Flood Risk Assessment Addendum Rev1

117 – 119 Slack Road,
Manchester,
M9 8AZ

23 November 2021

Figure 1 - EA LiDAR Data

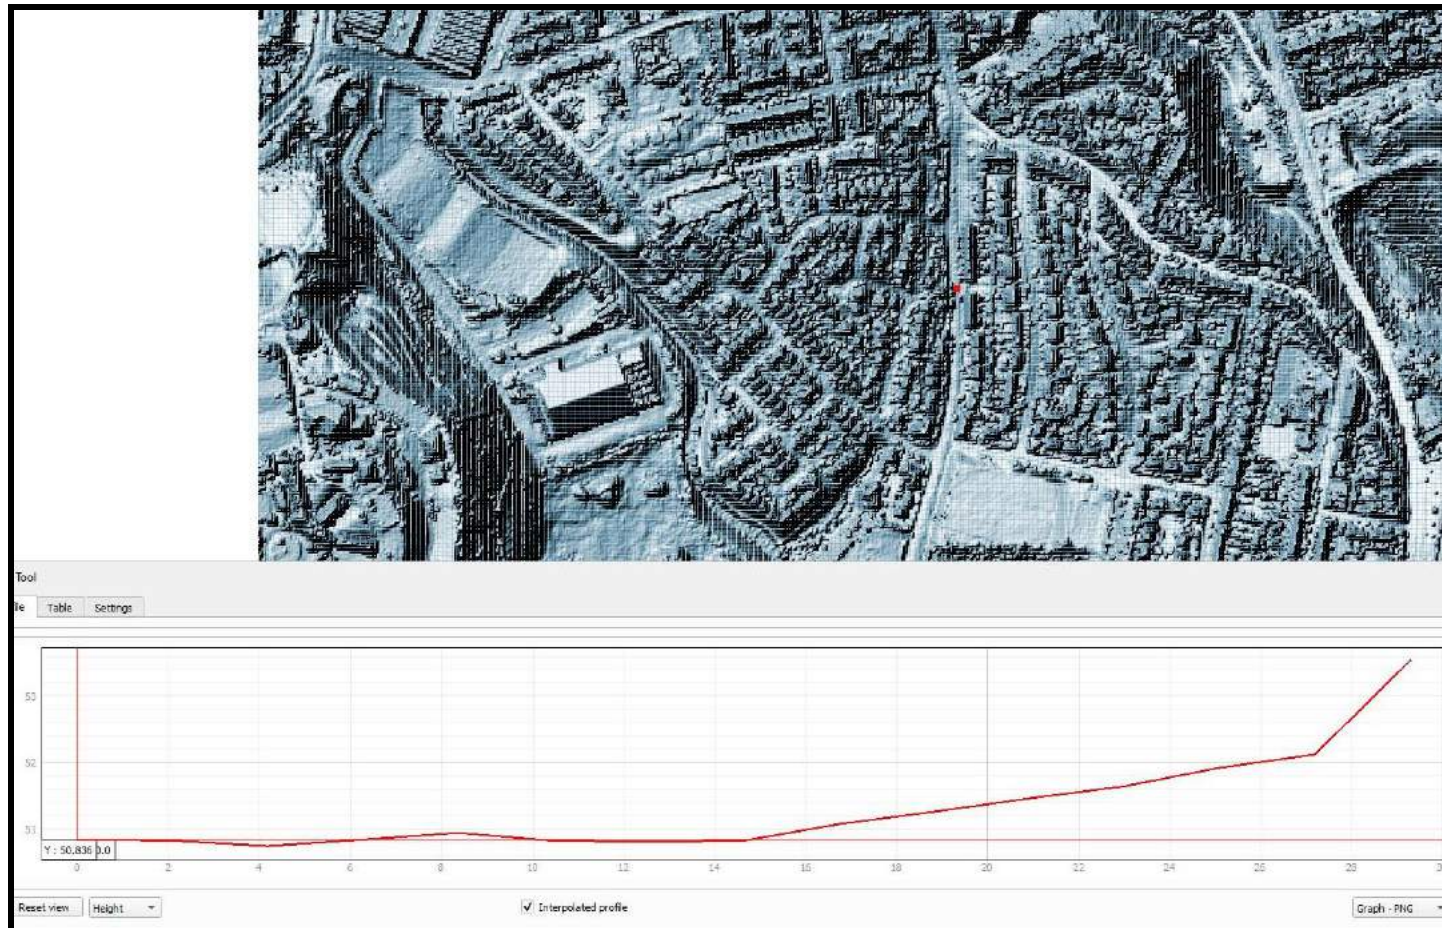
- While the additional information does provide some clarification to my [below] points, I would need to see the FRA updated to include the updated information and reassess the level of flood risk posed to the new development.*
- In addition, I would also like to see an assessment of raising the finished floor levels 300mm above the 1 in 100 year flood event (including climate change if possible, and if this is not possible flood resistant building techniques and materials should be considered) as per the standing national advice.*

- At the modelled node location nearest to the site (Node 3), flood levels are shown to be:
 - 1 in 100 year – 51.07m AOD
 - 1 in 100 year plus 35% CC - 51.19m AOD

- 1 in 100 year plus 70% CC – 51.27m AOD
 - 1 in 1000 year – 51.25m AOD
- LiDAR data has been obtained from the EA (see **Figure 1** overleaf) and a desktop study of the site levels has been undertaken by KCS Ltd.

- The road level at the entrance to the site is 50.83m AOD
- On this basis, (and recognising that the road level is lower than existing site levels) potential depths of flooding would range from 240mm in the 1 in 100 year event, rising to 360mm in the 1 in 100 year plus 35% allowance for climate change and 440mm in the 1 in 1 in 100 year plus 75% allowance for climate change.

Figure 2 - Possible Flood Displacement Routes

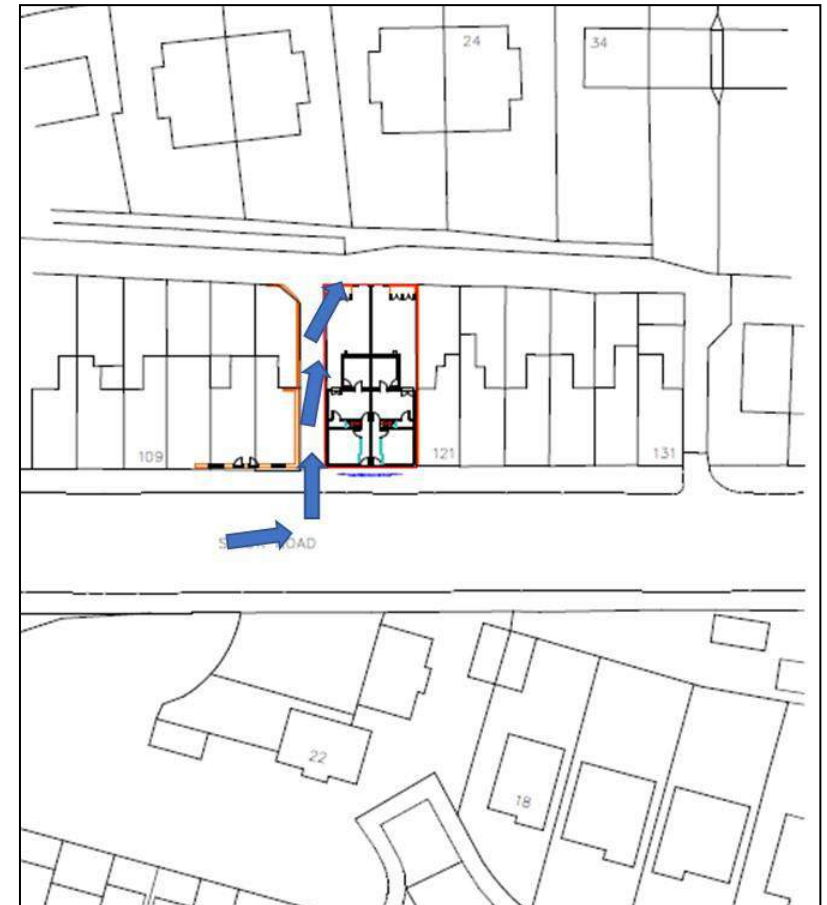
- 3. The FRA should assess the risk of the development displacing flood water and how this will impact on surrounding properties.*
- 4. The FRA should include an evacuation plan identifying safe access and egress routes. We would also encourage that the properties are registered with the EA to receive early warnings of flood events*

It is important to note that, immediately to the north of the portion of land proposed for development, is a footpath. This, and the rear of the site (and the rear of the adjacent properties) are shown to be in Flood Zone 1 (see **Figure 3** overleaf)

Should any floodwaters be displaced by the development, the floodwaters could flow down the footpath towards the rear of the proposed site.

Figure 3 - Access and Egress Route

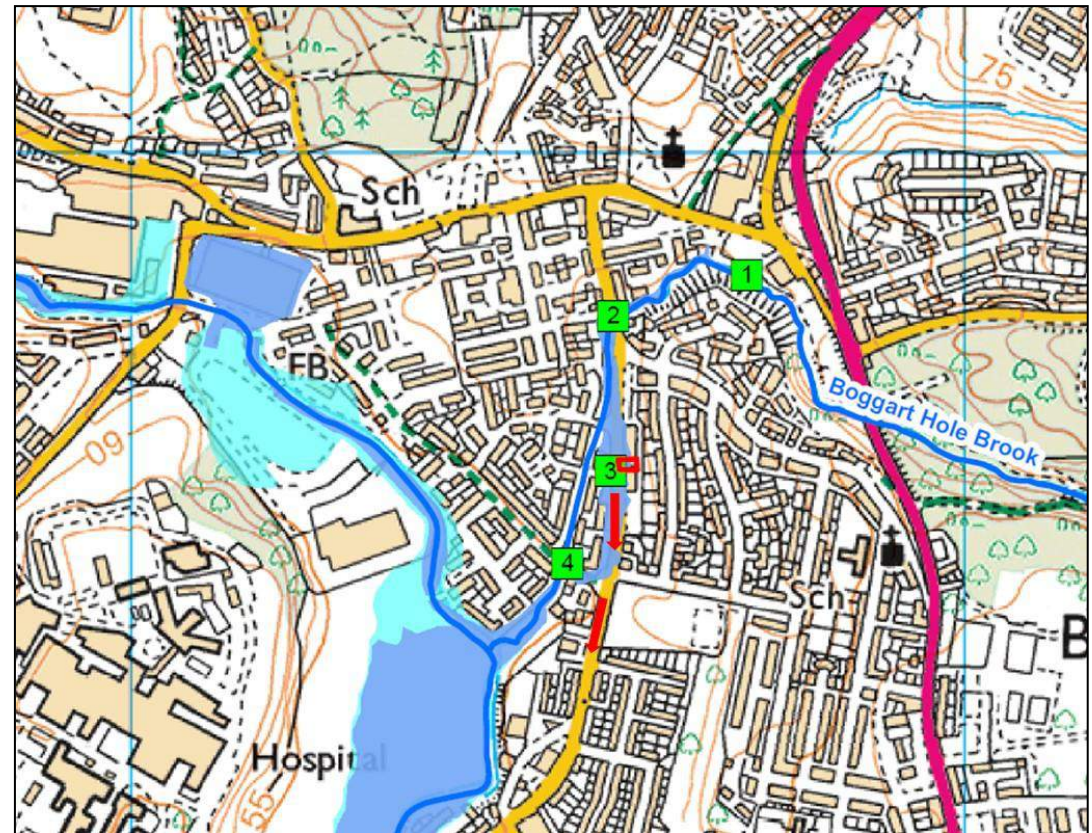
The FRA should include an evacuation plan identifying safe access and egress routes. We would also encourage that the properties are registered with the EA to receive early warnings of flood events

However, it is good to be mindful of the predicted extent of flooding, and where the safest places are likely to be in the event of a flood.

This safe route is based on the fluvial flood outlines and surface water flooding risk. In this instance, it would appear that leaving the property and travelling down Slack Road in a southerly direction (away from where Boggart Hole Brook crosses Slack Road) would be the best option.

Appendix C - Section Plan (prepared by KCS Ltd)

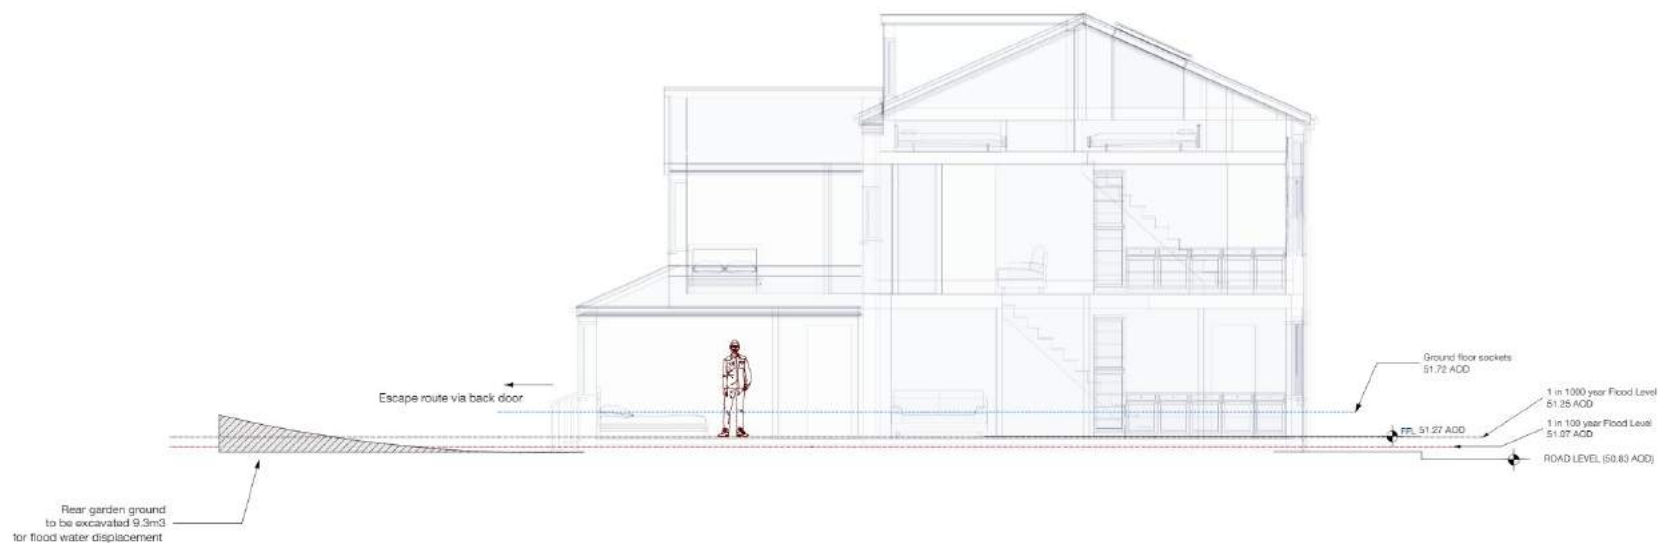
- 1. The appendices referred to within the FRA have not been attached, these will need to be reviewed before the FRA can be approved.*
- 2. The finished floor levels of the property should be compared directly to the EA flood level data and be set a minimum of 300mm above the 1 in 100 year flood event (plus climate change), if this is not feasible then appropriate flood mitigation measures should be implemented (such as raising sockets above the 1 in 100 year flood event plus climate change) – all mitigation measures should refer to the predicted flood levels.*

-
- *I would also note that I would like to see an update of the excavation calculations (following confirmation of existing site levels) to avoid flood water displacement from the proposed property, this should again be discussed within the FRA.*

- A Section Plan has been provided by KCS Ltd. A copy of this is provided in **Appendix C** of this Addendum.
- As shown on the plan, finished floor levels are to be set at 51.27m AOD, which is the 1 in 100 year plus 75% allowance for climate change level and provides a 200mm freeboard above the 1 in 100 year modelled flood level.

- Compensatory storage will be provided at the rear of the property which is located outside of the flood extents; the land will be lowered to provide 9.3m³ of flood compensation. Channels will be provided to direct any flows to this lowered area of land.
- KCS Ltd calculated the volume of land from the elevation rise measured onsite which agrees with the lidar elevation data.
- The rear garden rises steeply towards the rear. Therefore, as part of the landscaping this portion of site will be levelled with the house.
- The Section Plan provided in **Appendix C** shows the location of the compensatory storage.
